March 9, 2016

**Re: Comments on the Final Consolidated Environmental Impact Report  
for the Willow Springs Solar Array Project (PP10232) (State  
Clearinghouse No. 2010031023)**

Figure A. Soil types present on the Project site.<sup>70</sup>

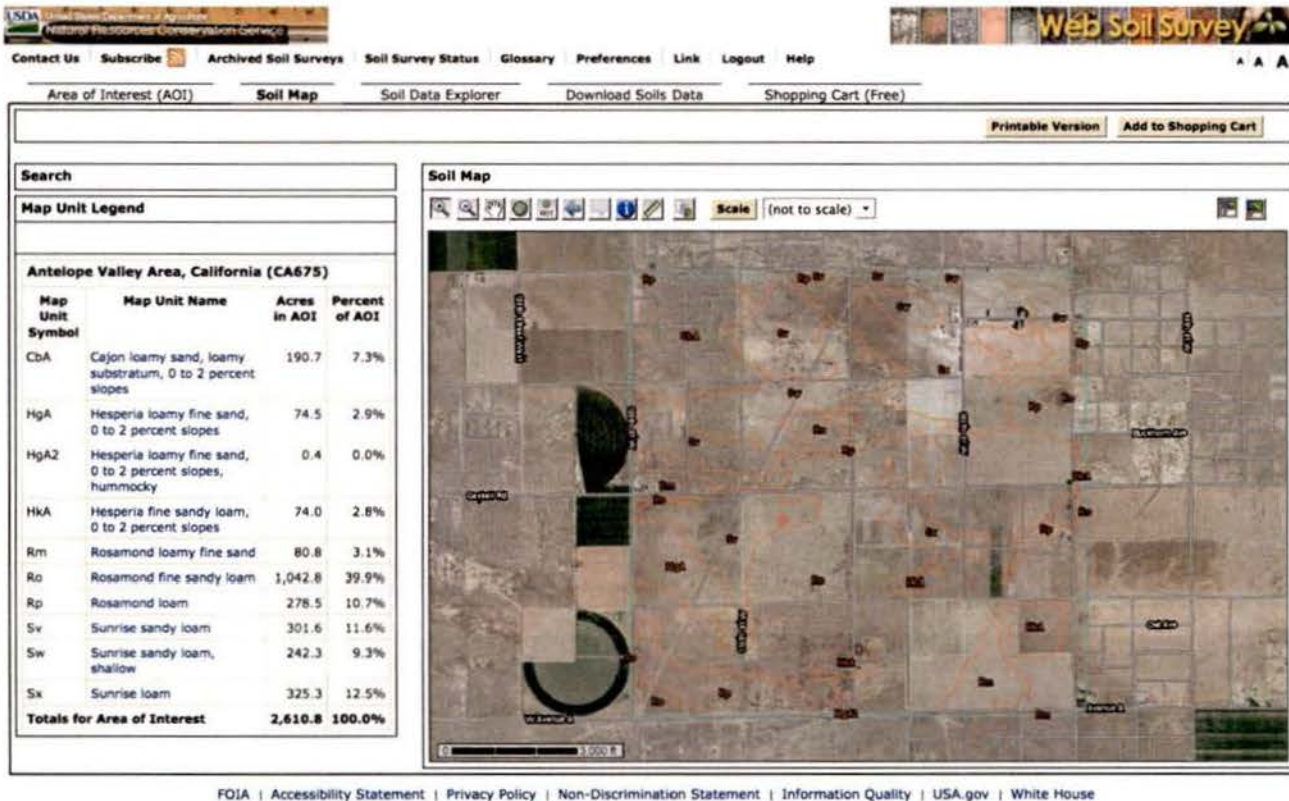
In any case, differences in habitat conditions between the two sites is irrelevant because: (a) both the BRTR and RDEIR acknowledged the Project site contains suitable habitat for the species; and (b) the basis for concluding a “low” potential for the species to occur at the Project site was incorrect (i.e., association with water and proximity to closest known habitat).<sup>71</sup>
